Approved Septic System Plan
Howard County Health Department

LOT 92

WEST FRIENDSHIP ESTATES SECTION 1 PLAT No. 9936

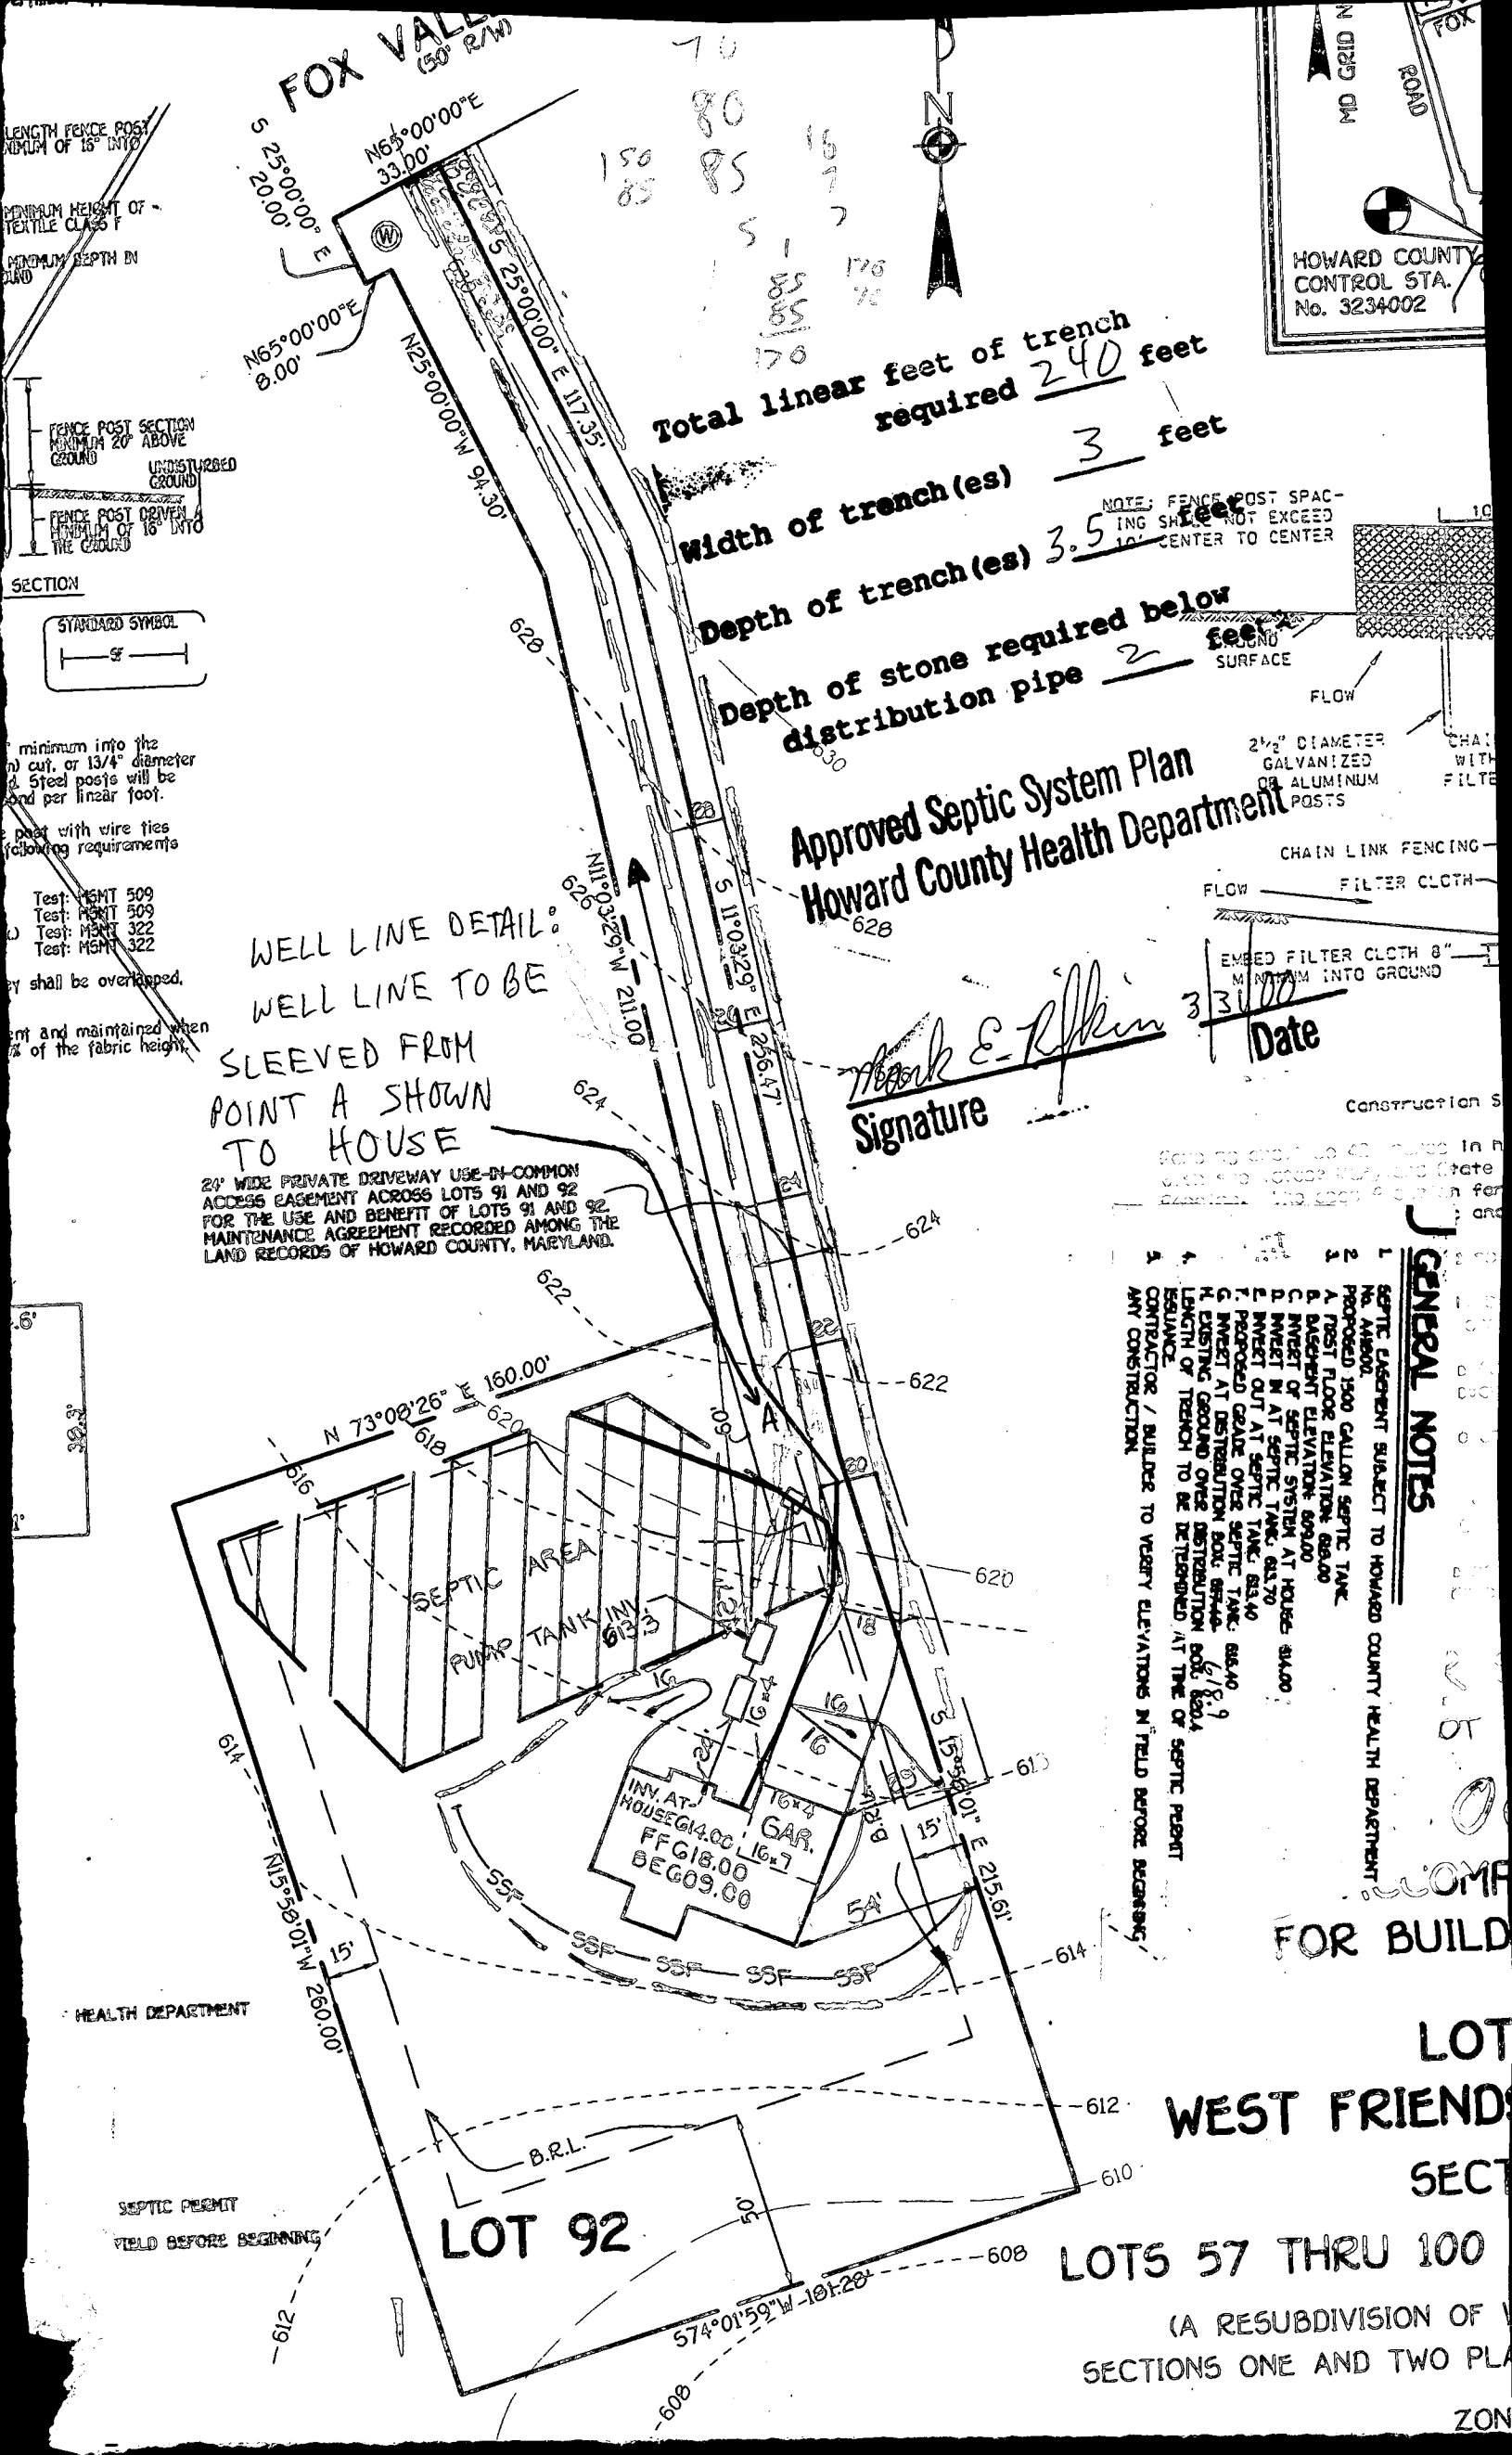
PRE-CONSTRUCTION INSPECTION: 5/19/00 Met with septic and plumbing contractors, advised them of well line sleeving and placement. To have easement area

INSPECTION COMMENTS: staked to avoid confusion. Contour similar to our data. (BB)

5/26/00 Well line sleeving looks good. House connection: for septic will have to be relocated. Well contact builder (BB) 6/2/00 House connection made. O.K. to cover tanks. Well line relocated to side of house. Line covered but septic contractor said it was sleeved. Well line location is approximate. (BB)

6/7/00 - OK TO FINISH AND COVER ALL WORK, PUMP TEST STILL NEEDED (SRK)

7/3/00 - PUMP AND ALARM OPERATIONAL - OK (SRK)
